TRANSPORTATION ADVISORY COMMITTEE.

Date: September 1, 2020.
To: Adam Chapdelaine, Arlington Town Manager.
From: TAC Arlington High School Working Group.
Subject: Arlington High School Supplemental Traffic Impact Analysis Review.

Memorandum.

Overview of Limits

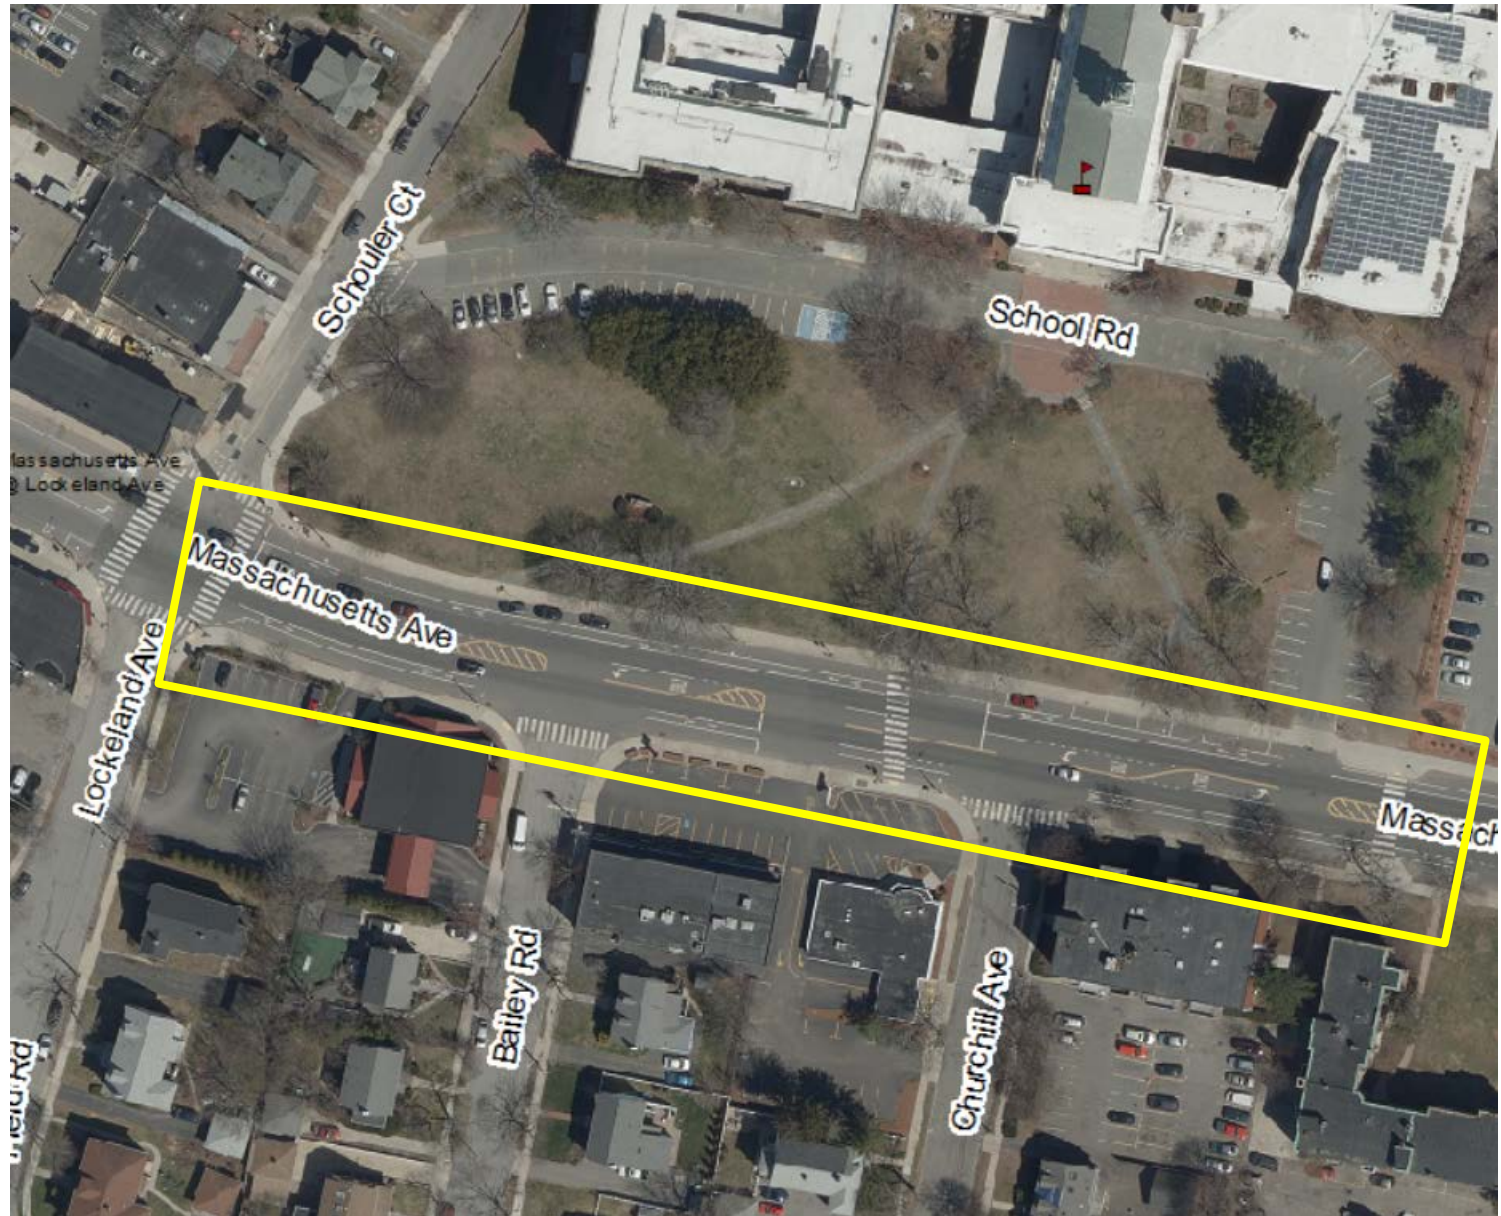
At this time, a cycle track or cycle track elements cannot be implemented on Massachusetts Avenue without obtaining additional right-of-way. The existing cross section of Massachusetts Avenue between Schouler Court and Newman Way (opposite CVS) is 75 feet. This allows for an eight and half-foot sidewalk, eight-foot parking lane, five-foot bike lane, and 11-foot vehicle travel lane on each side of the roadway plus a ten-foot center turn lane. To convert the existing bike lane to a cycle track between the parking lane and sidewalk, a three-foot separation between the parking lane and bike lane would be required. This separation is needed so that a bicyclist is not hit by the opening of the passenger side door of a parked car. According to the Supplemental TIA the additional three feet on each side of the roadway would need to be taken from the existing lanes and/or sidewalk, or the right of way would need to be increased by six feet.

Mass Ave @ AHS with Cycletrack (v.1) (Looking East)

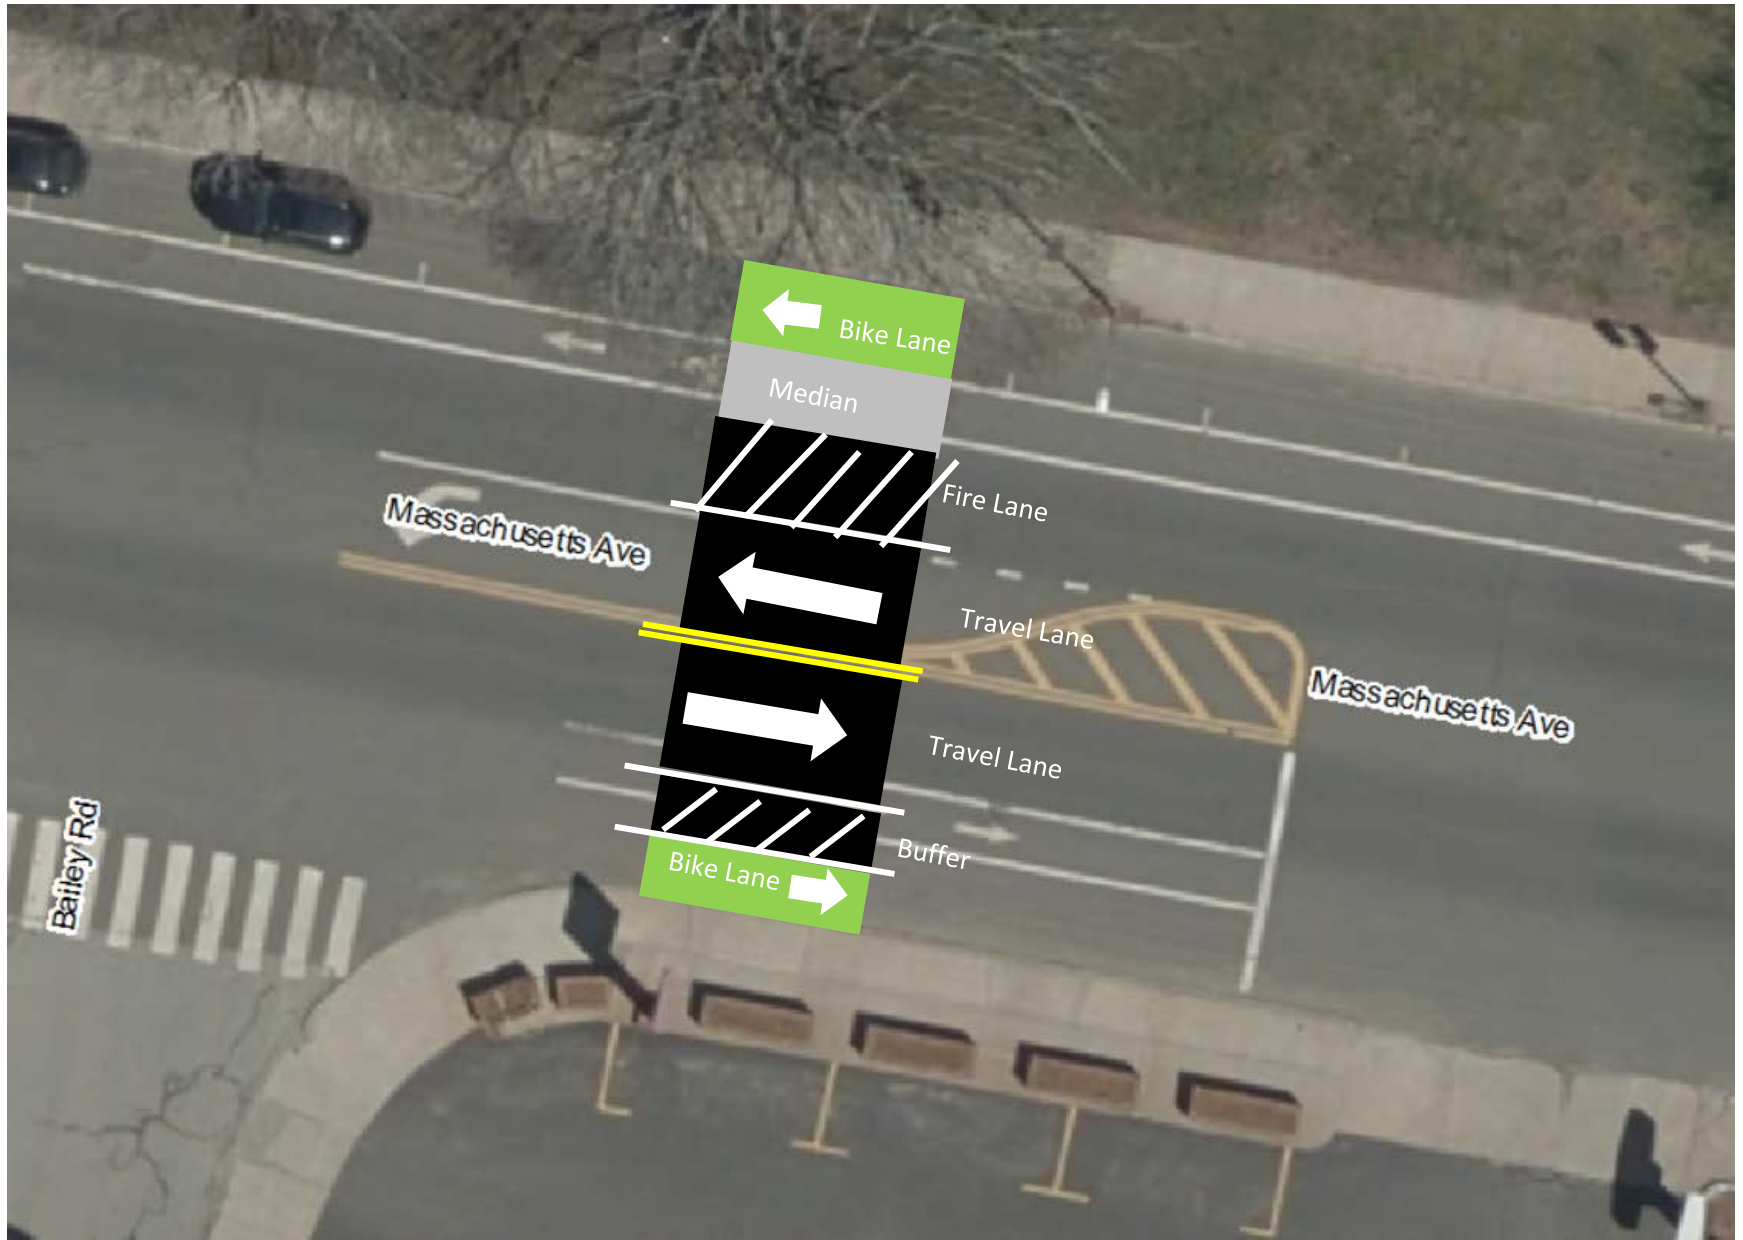
The working group disagrees with this assessment and recommends that further consideration be given to the installation of a cycle track. Attached to this memo are two concepts for a cycle track that would not require additional right-of-way. Both concepts require the removal of the

center turn lane. Version 1 has fairly wide travel lanes (13') that would allow left-turning vehicles to be passed on the right, mitigating the loss of the center turn lane. This would only impact westbound traffic because there will be no driveways on the north side of Massachusetts Avenue. Both concepts would retain the existing sidewalks on both sides of the roadway and would require transitions between the cycle track and the existing roadway cross-section at either end.

Version 1 would also eliminate parking on the south side of Massachusetts Avenue. The south side parking, particularly between Lockeland Avenue and Churchill Avenue, is limited because of fire hydrants, driveway curb cuts, and the crosswalk across Massachusetts Avenue at Churchill Avenue, leaving room for about eight legal parking spaces. There are about another seven spaces between Churchill Avenue and the CVS. The businesses on the south side of the street have off-street parking, and short-term parking is available on the side streets. Therefore, any parking impact should be limited.

In Version 1, the seven-foot bike lane on the high school side would be raised to the level of the sidewalk and would include a seven-foot wide raised median between the raised bike lane and the roadway. This would make it easy for students to cross the bike lane and would not require additional curb cuts. The curb on the AHS side would be shifted 14 feet to the south to accommodate the raised bike lane and median. A six-foot bike lane would be provided on the south side of the road separated from the traffic lane by a four-foot striped buffer with three-foot high flex-posts.

Version 2 retains an eight-foot parking lane on the south side of Massachusetts Avenue. There may be some loss of parking due to the need to preserve sight lines for the bank driveways and the intersections with Bailey Road and Churchill Avenue, but not a complete loss as in version 1. The parking lane would be separated from the sidewalk by a street level six-foot bike lane and a three-foot striped buffer with three-foot high flex-posts between the bike and parking lanes.

The Version 2 concept has 11-foot travel lanes, which is the MBTA minimum to accommodate buses. The seven-foot fire lane would generally allow westbound vehicles to pass westbound left-turning vehicles, mitigating the loss of the center turn lane. In contrast to Version 1, the six-foot bike lane would be kept at street level and would be separated from the fire lane by a six-foot raised median which would not be connected to the existing curb. The raised median is needed to prevent vehicles from crossing the bike lane to reach or leave the current curb for drop-off and pick-up. A curb opening would be required in the median at the Massachusetts Avenue crosswalk to provide an accessible path.
